## **KNOWLES ADDITION TO TEMONIA SUBDIVISION**

APPLICATION NUMBER 26 DATE April 17, 2008

REQUEST Subdivision

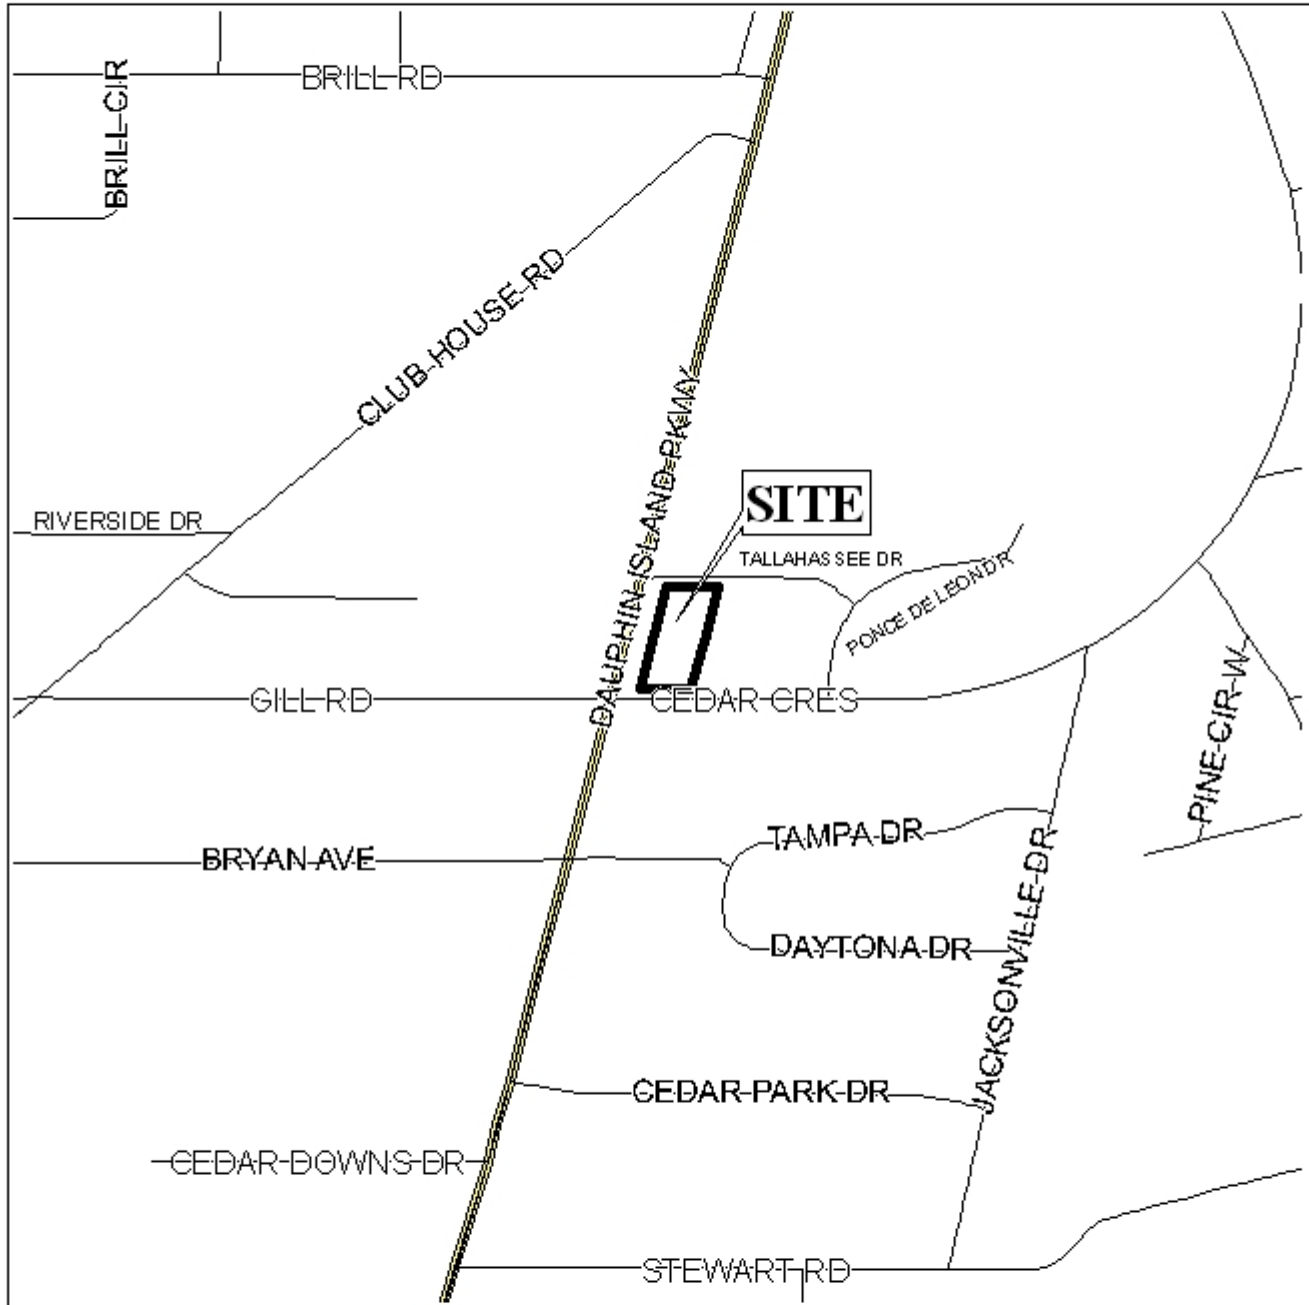
The site fronts Dauphin Island Parkway, Tallahassee Drive and Cedar Crescent Drive, with 50' of right-of-way illustrated for each street on the preliminary plat. However, Dauphin Island Parkway is a major street in accordance to the Major Street Component of the Comprehensive Plan; therefore, requiring a minimum 100-foot of right-of-way; therefore, the dedication of 50-feet of right-of-way from the centerline of Dauphin Island Parkway is required.

As proposed, Lots 1 and 3 have approximately 133-feet+ of frontage along Dauphin Island Parkway and approximately 80-feet along Tallahassee Drive and Cedar Crescent Drive. As a means of access management, all lots should be limited to one curb cut, with the size, location, and design to be approved by Traffic Engineering and conform to AASHTO standards. Additionally, a note on the Final Plat stating that Lots 1 and 3 be denied direct access to Dauphin Island Parkway, would be required.

- 1) the dedication of sufficient right-of-way to provide 50-feet of right-of-way from the centerline of Dauphin Island Parkway;
- 2) placement of a note on the Final Plat stating that all lots are limited to one curb, with the size, location, and design to be approved by Traffic Engineering and conform to AASHTO standards;
- 3) the placement of a note on the Final Plat stating that Lots 1 and 3 are denied access to Dauphin Island Parkway;
